MIL-F-70518 (AR)
AMENDMENT 2
22 August 1990
SUPERSEDING
AMENDMENT 1
11 July 1988

MILITARY SPECIFICATION

FLARE, INFRARED TRACKING, MARK 33 MOD 0 (ARMY)
PARTS FOR AND LOADING, ASSEMBLING AND PACKING

Figure I: Method for Mounting the MK33 MOD 0 (Army) Flare on the 2.75 Rocket Motor

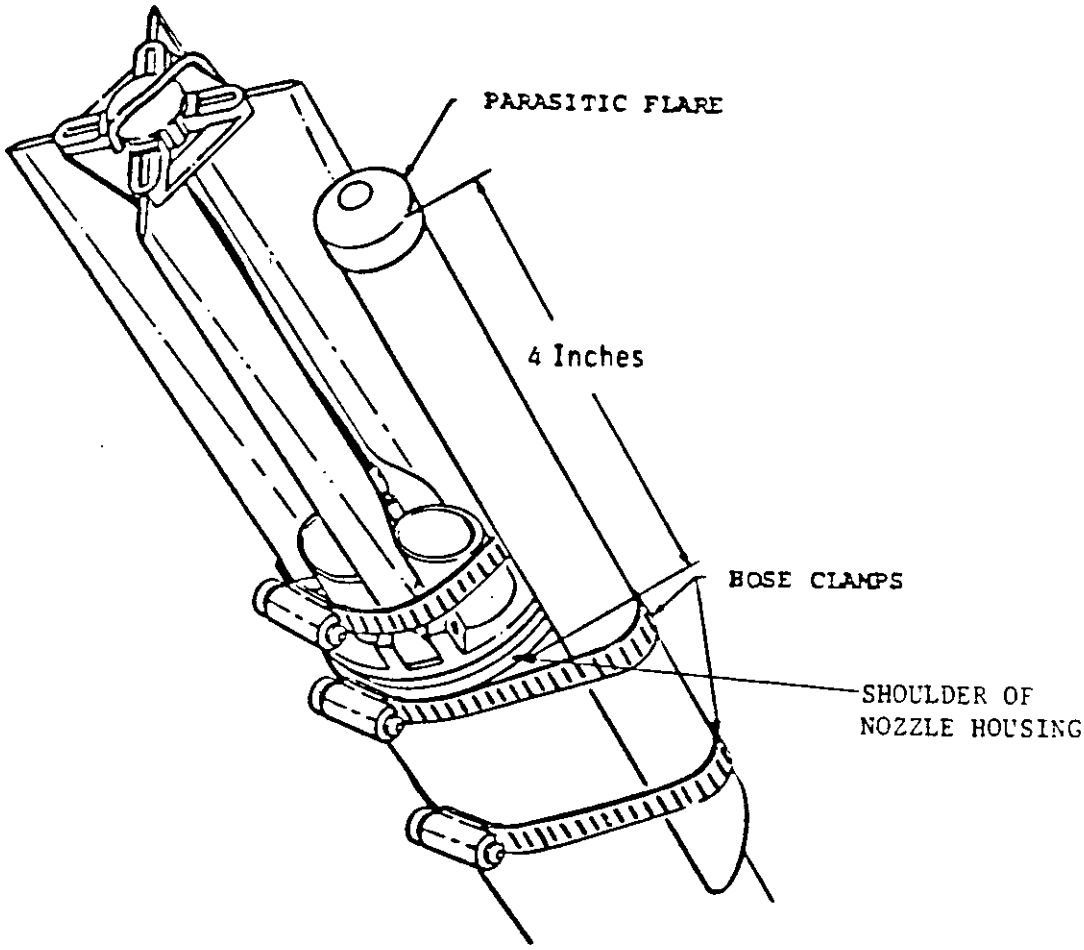
Substitute included "Figure 1".
